THE EFFICIENT 2-STORY  
436 NATCHEZ TRACE  
FUQUAY-VARINA, NC 27526

**436 Natchez Trace**  
**Fuquay Varina, NC**  
**Family Building Co.**

Job Number:  
1009-22

**S2**

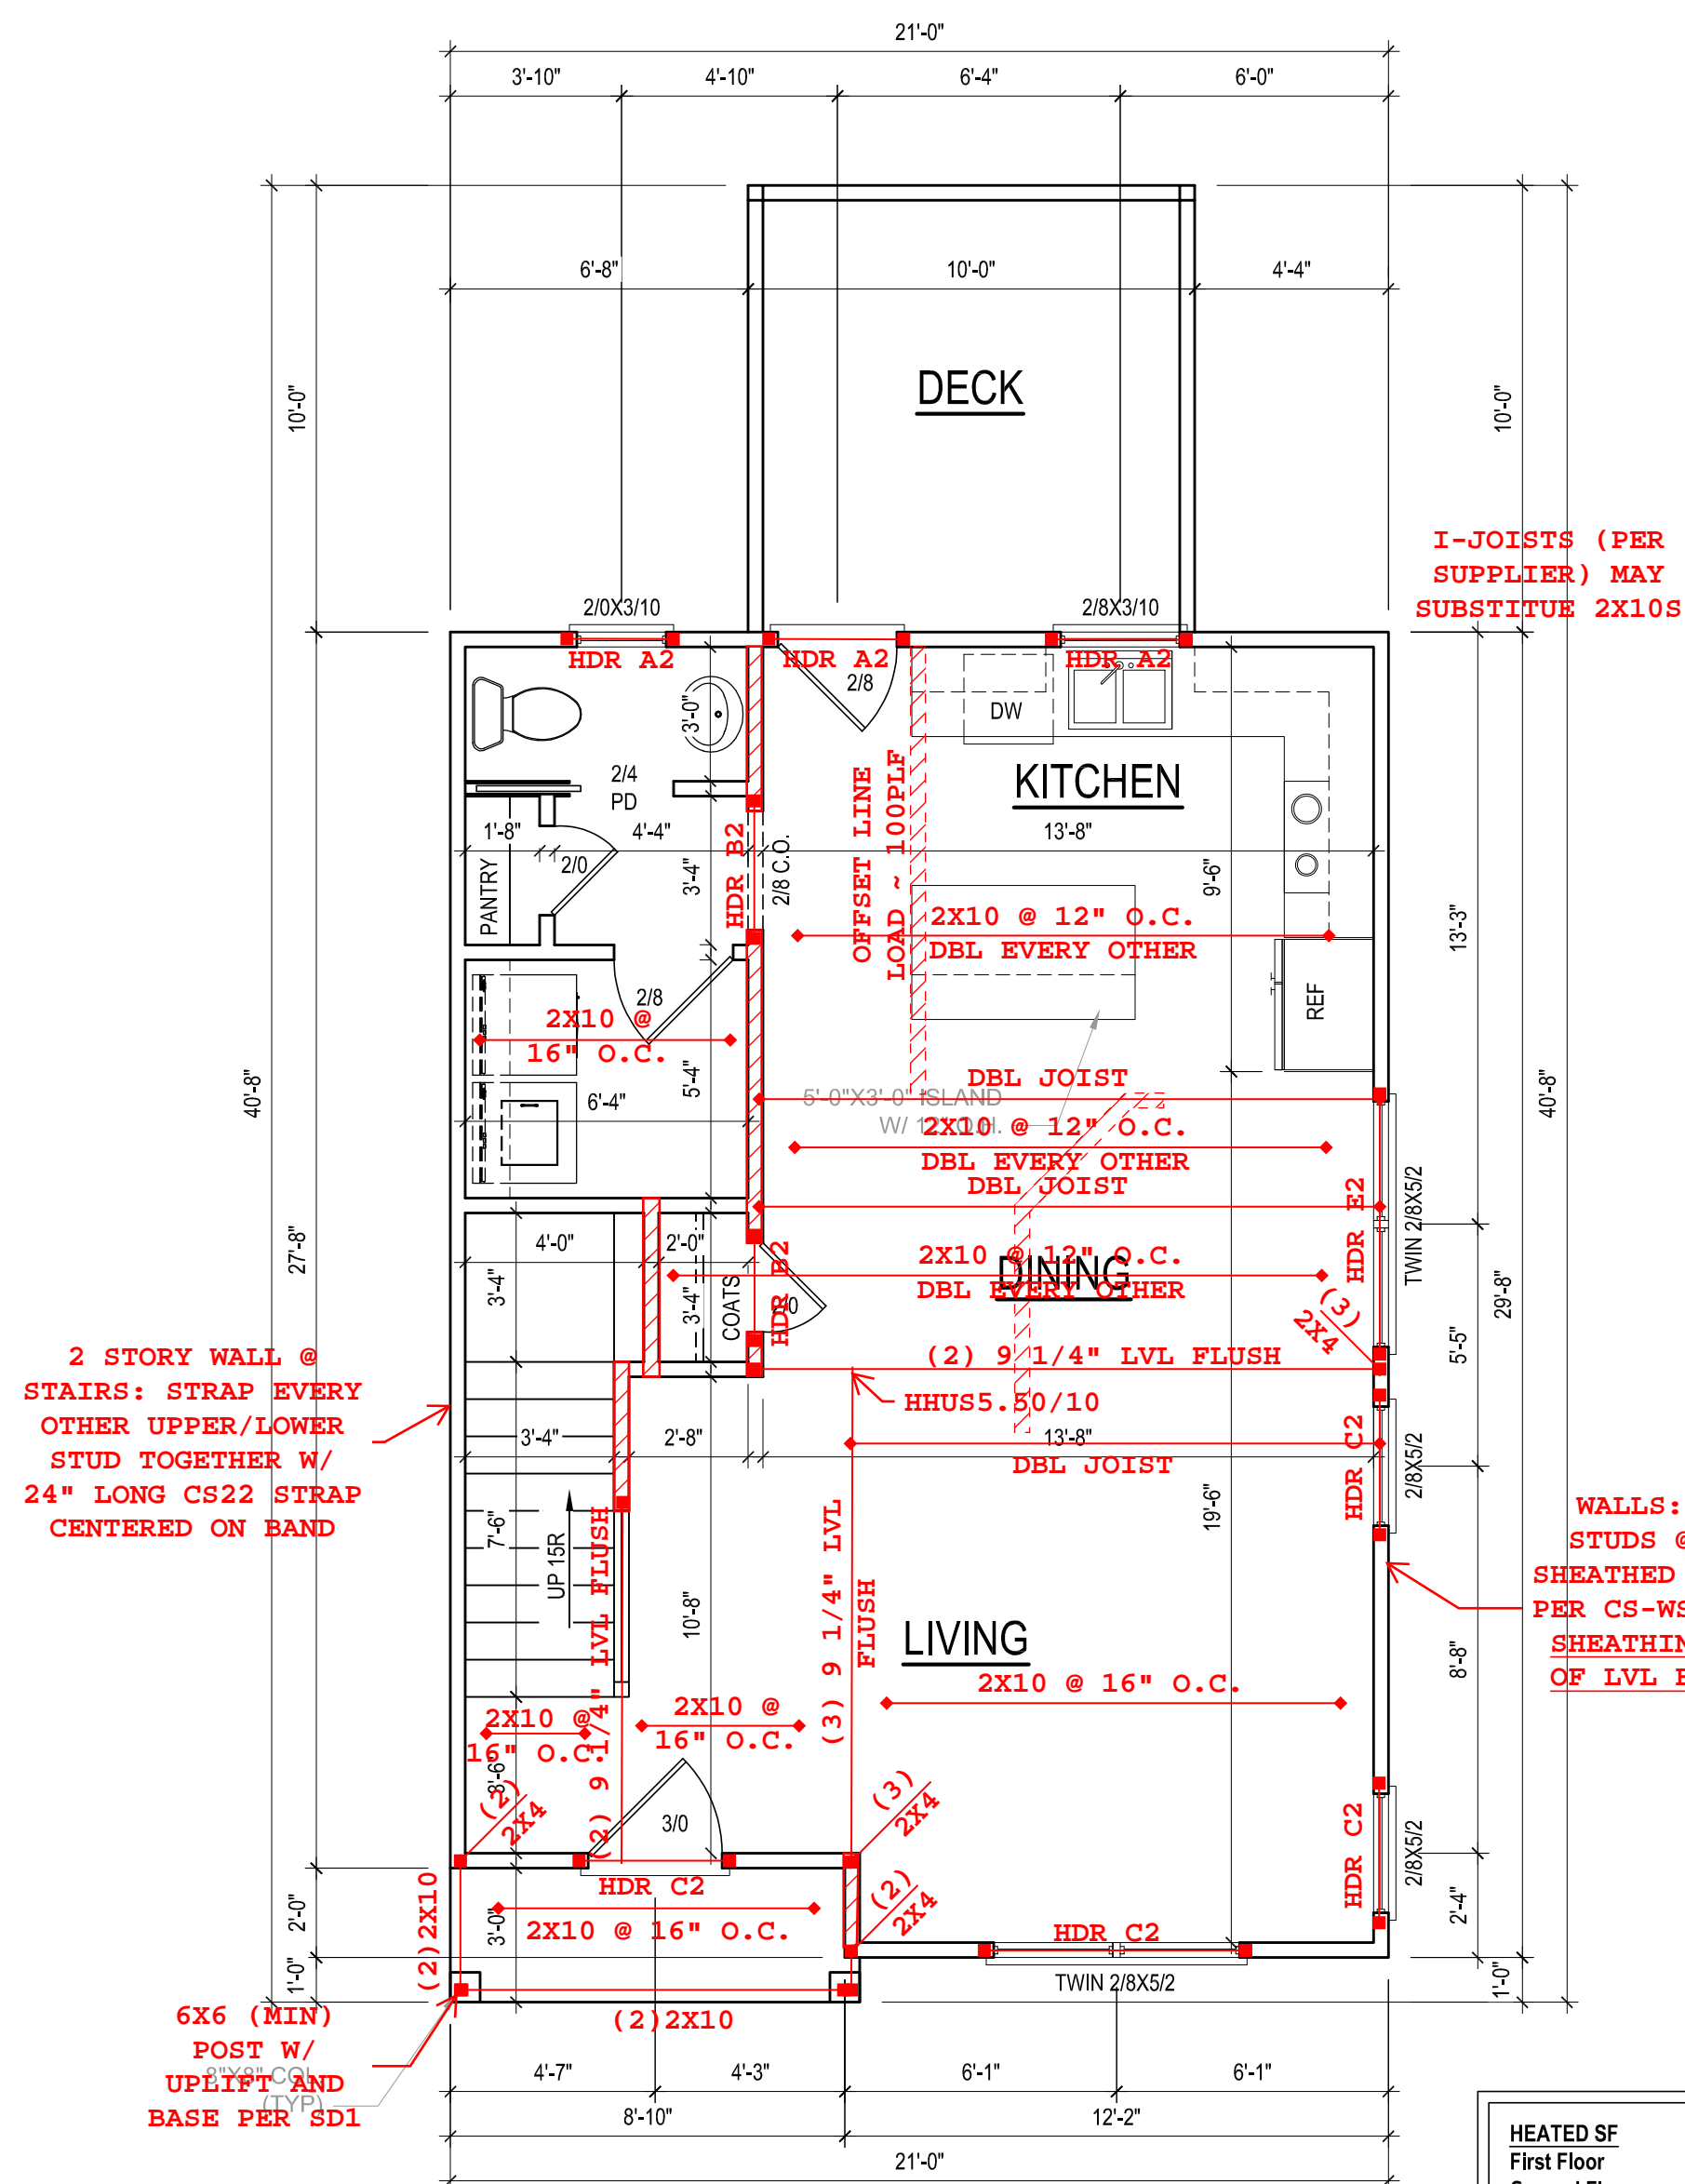
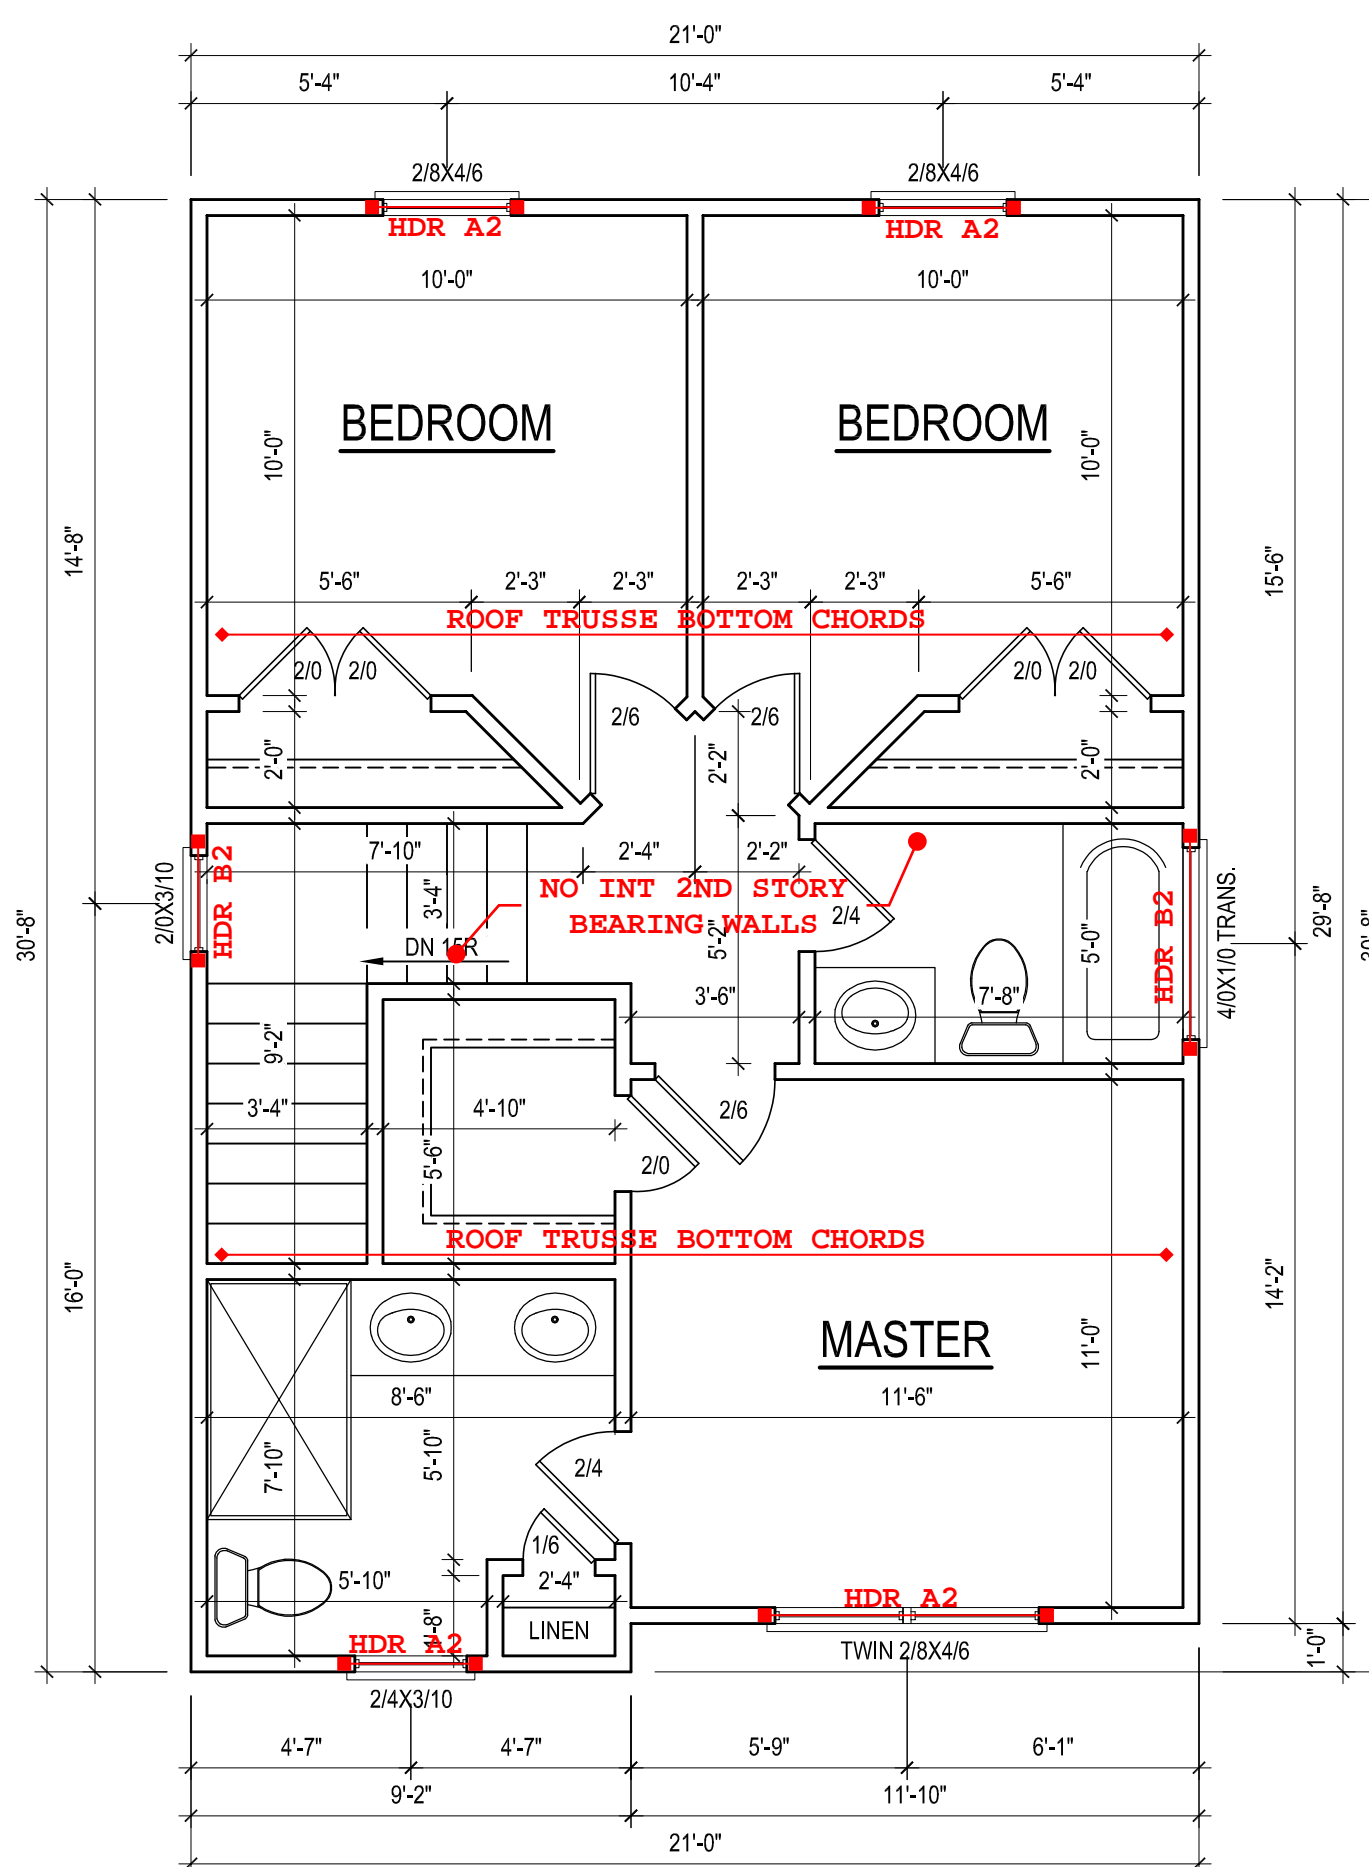
I-JOISTS (PER  
SUPPLIER) MAY  
SUBSTITUTE 2X10S

2 STORY WALL @  
STAIRS: STRAP EVERY  
OTHER UPPER/LOWER  
STUD TOGETHER W/  
24" LONG CS22 STRAP  
CENTERED ON BAND

WALLS: 2X4 WALL,  
STUDS @ 16" O.C.,  
SHEATHED W/ 7/16" OSB  
PER CS-WSP, EXTENDING  
SHEATHING TO BOTTOM  
OF LVL BANDS BELOW,  
TYP
